CASITAS DEL CAMINO

60th Street NW
Albuquerque, NM 87105

Number	Review Cycle	Department	Comment	Response
1	1	Planning	There is a discrepancy present in the Site Plan Sheets submitted in regards to the EV Parking. On Sheet S1.1 keyed note #25 calls out a need for minimum 10 EV parking spaces on site. On Sheet S1.0 and on the TCL it shows the site plan calling out only 8 EV parking spaces. Please correct the discrepancy shown on sheet S1.1.	A total of 8 EV parking spaces are to be provided. Please see corrected parking calculation shown on S1.0. An updated TCL with that correction is in the process of being submitted to the city of Albuquerque.
2	1	Planning	Ensure all dimensional standards are being adhered to and are clearly called out on the plans.	All dimensional standards are being adhered to and are called out on the plans.
3	1	Planning	Provide the Usable Open Space calculations on the LS Plan sheet outlining what the Usable Open Space will be for the subject property.	Usable Open Space calculations have been provided. Please see them on Sheet S1.0.

sheet no: LS-102

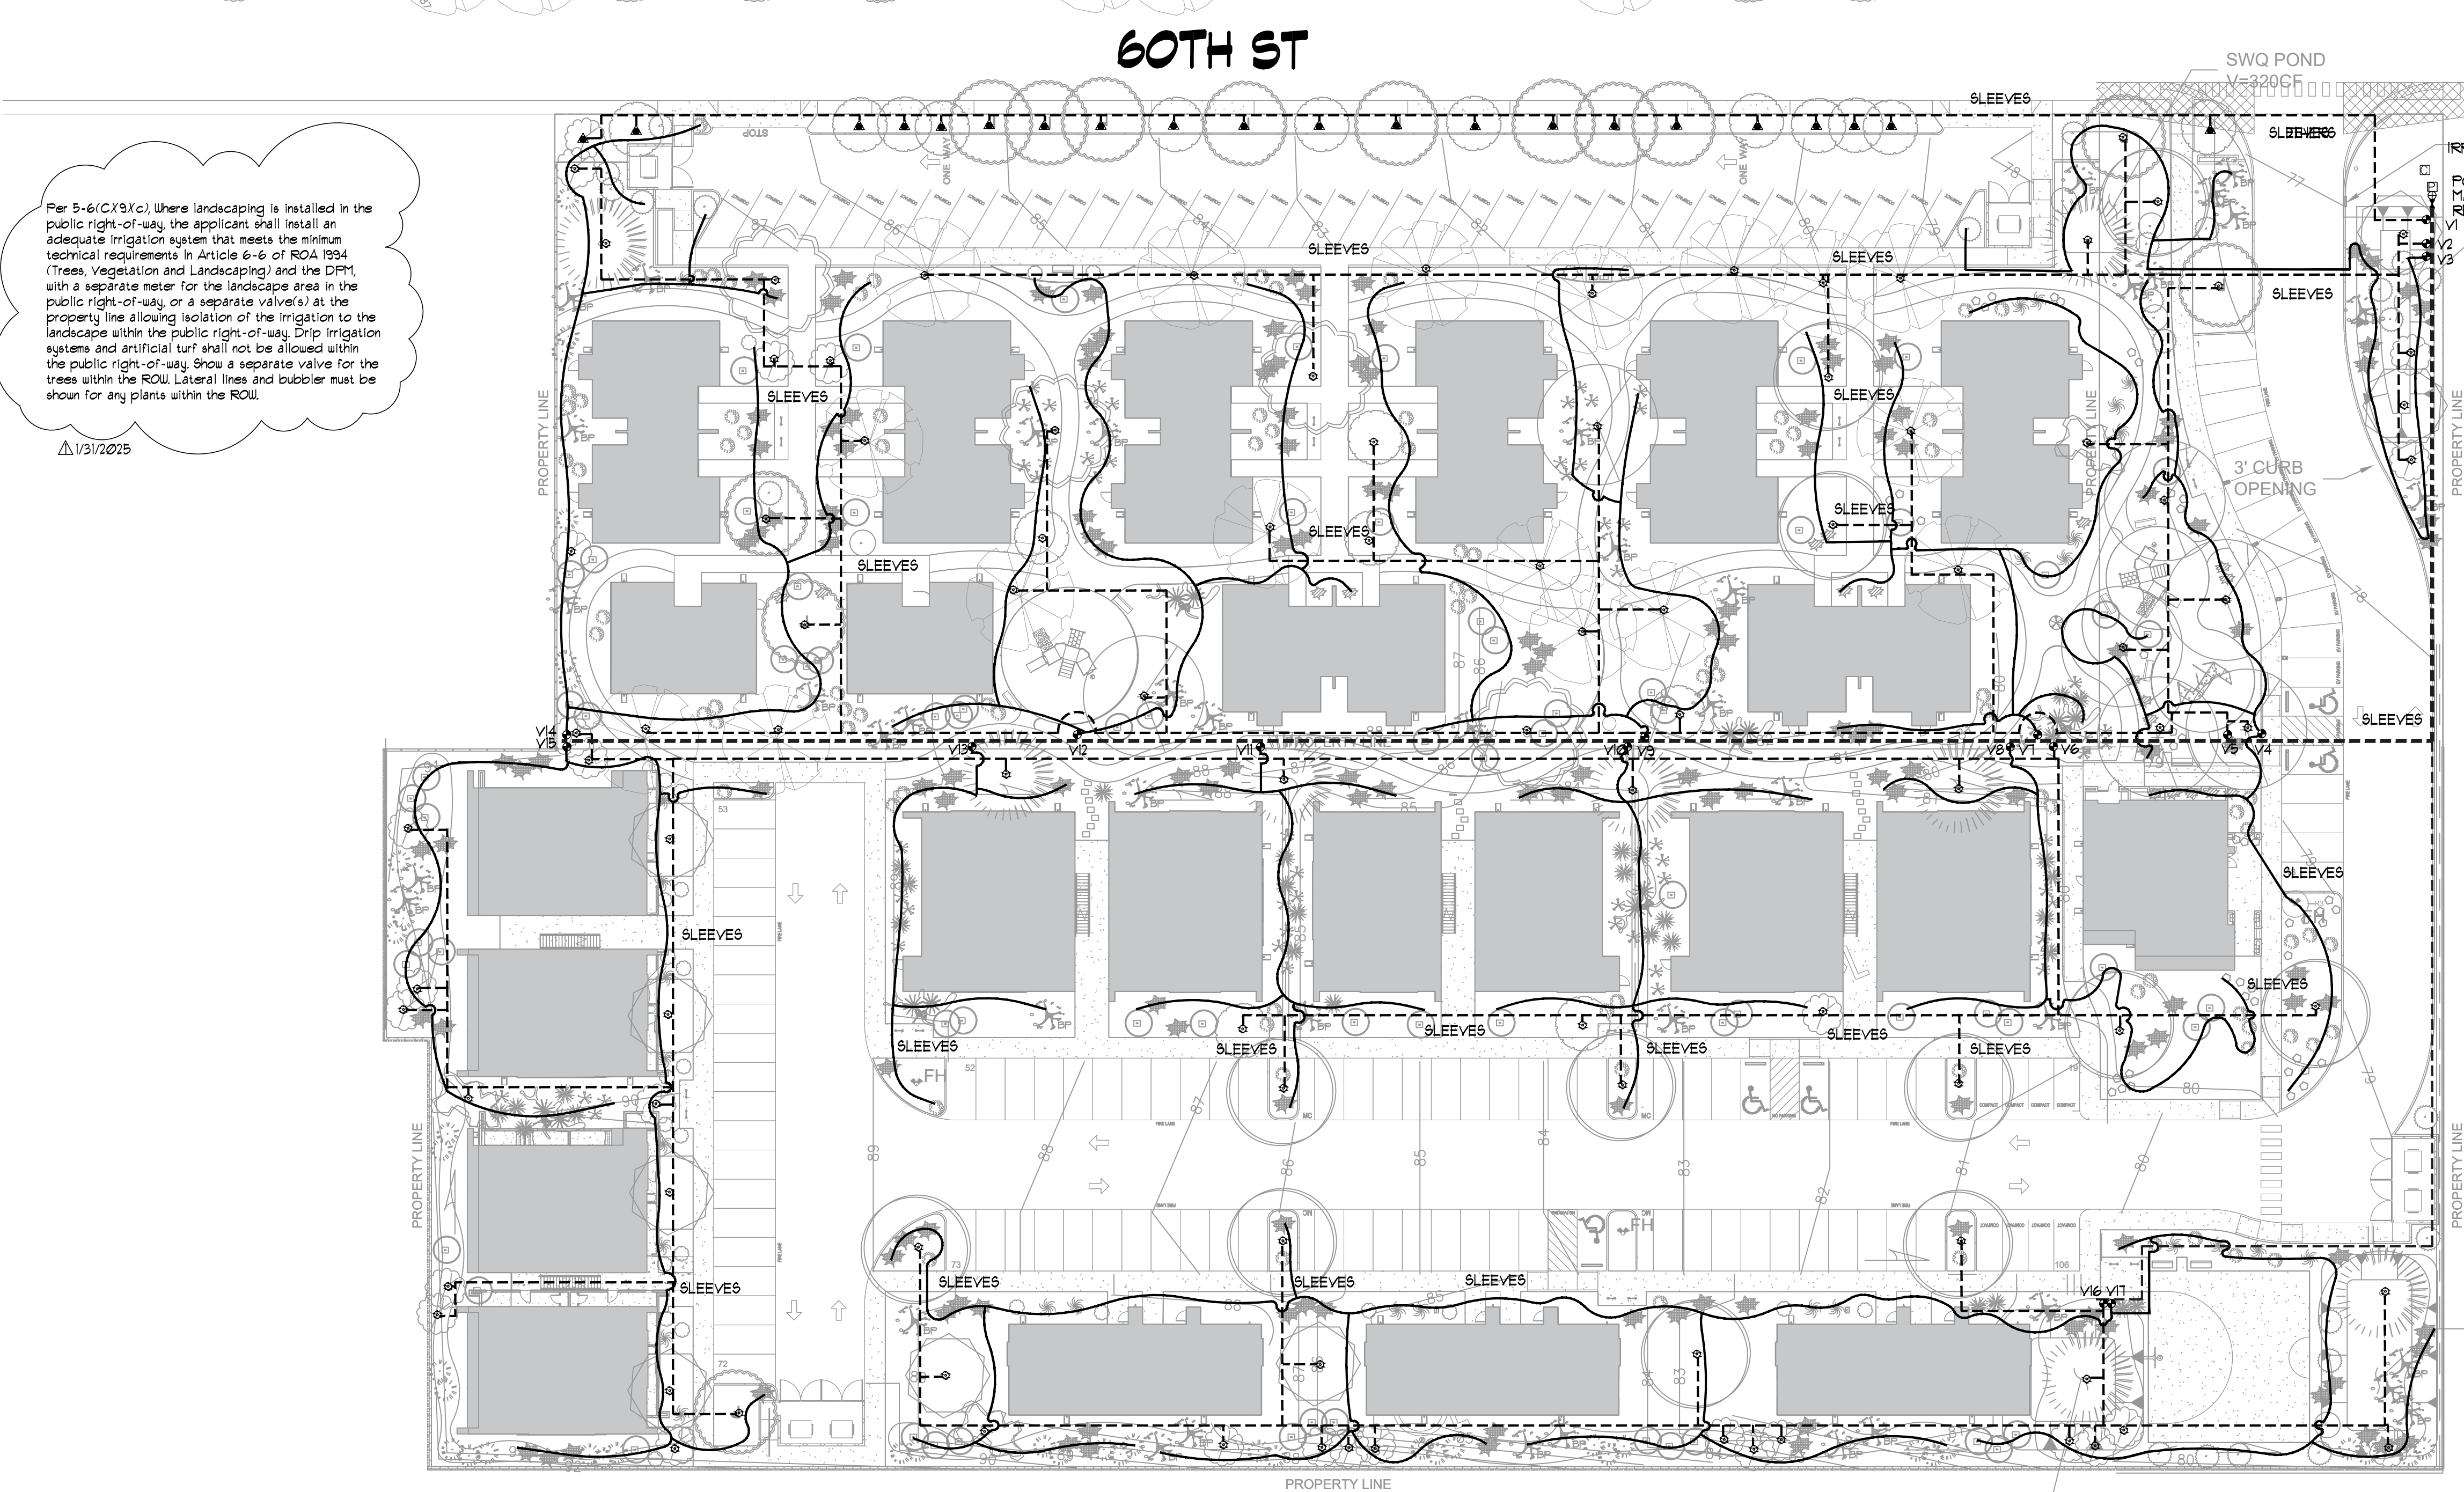
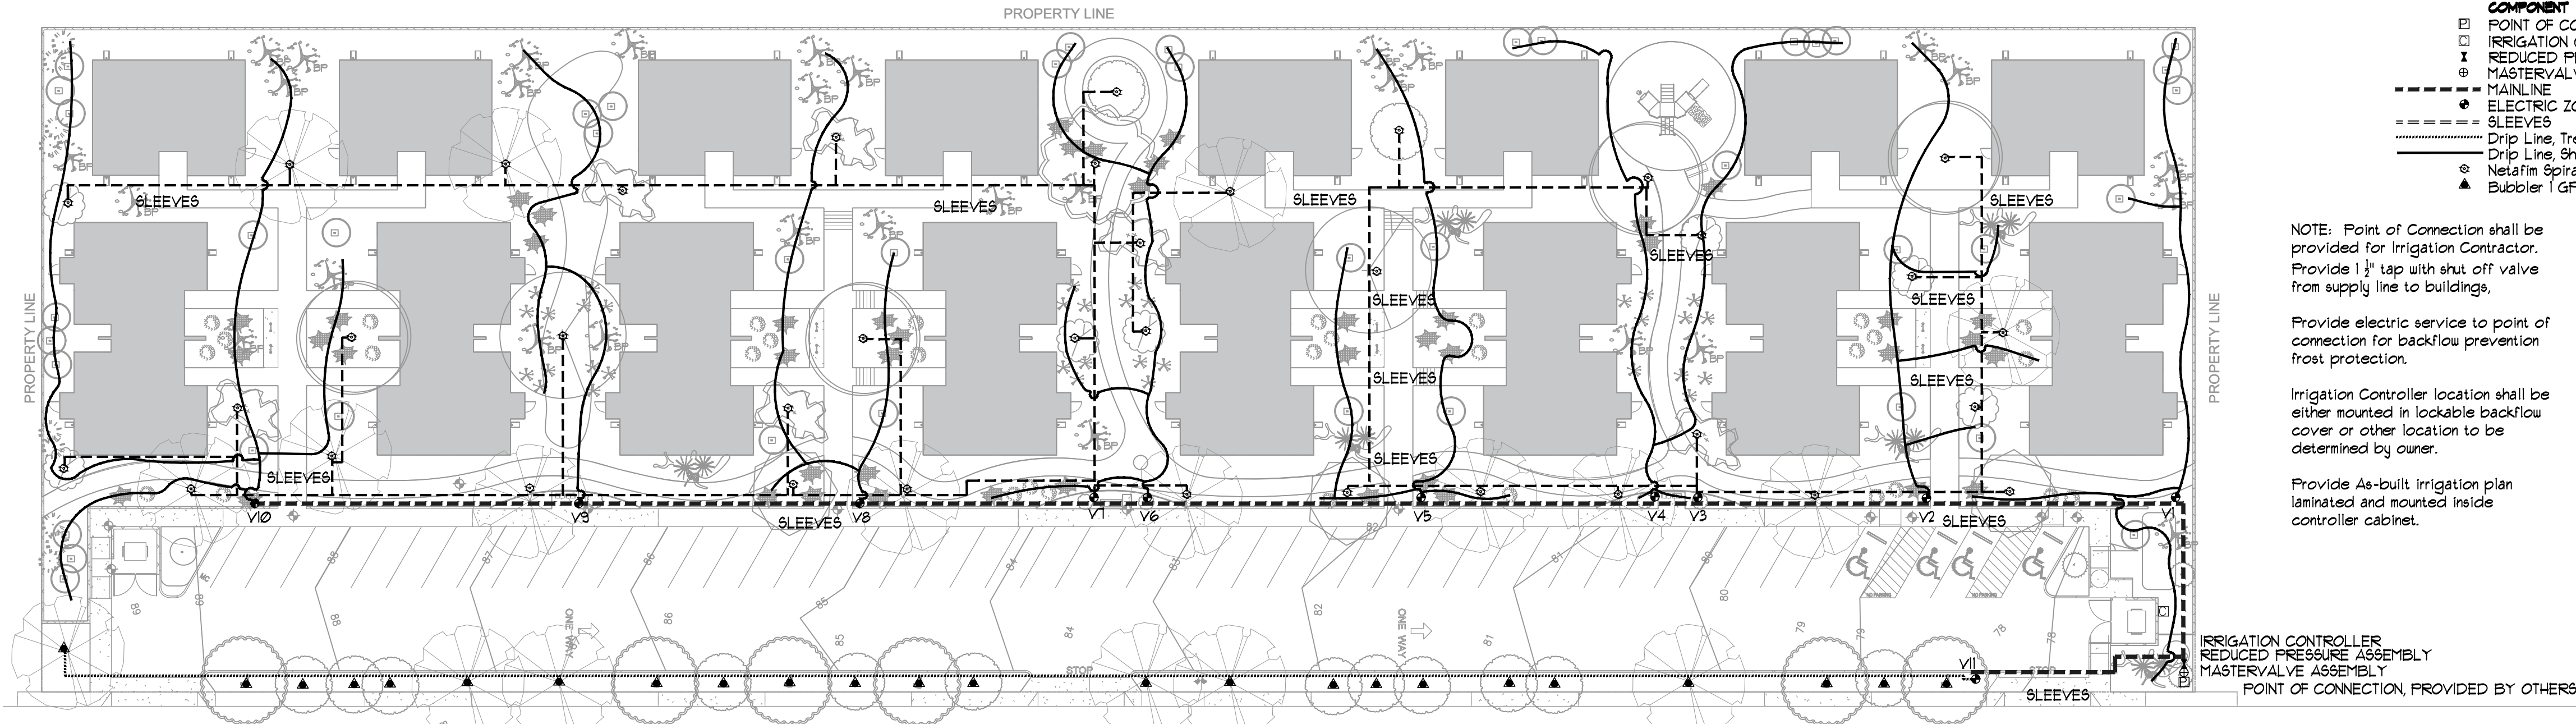
20	1	Code Enforcement	Provide elevations showing windows will be recessed at least 2 inches and the west facing facades have heat mitigation features.	A general note staing "All windows to be recessed a minimum of 2" from exterior finish surface" has been added to building elevations. Please see sheets A1.12, A1.22, & A1.32. For west facing fascades, we have included trees in locations that will help medigate the heat from the western sun.
21	1	Code Enforcement	Landscaping plan must comply with the current requirements of the IDO; the note shown below regarding woodmulch must be removed from the Landscape Plan.	Referenced note has been removed from the landscape drawings.
22	1	Code Enforcement	Per 5-6(C)(9)(c), Where landscaping is installed in the public right-of-way, the applicant shall install an adequate irrigation system that meets the minimum technical requirements In Article 6-6 of ROA 1994 (Trees, Vegetation and Landscaping) and the DPM, with a separate meter for the landscape area in the public right-of-way, or a separate valve(s) at the property line allowing isolation of the irrigation to the landscape within the public right-of-way. Drip irrigation systems and artificial turf shall not be allowed within the public right-of-way. Show a separate valve for the trees within the ROW. Lateral lines and bubbler must be shown for any plants within the ROW.	Shown on Sheet LS-102, noted and clouded
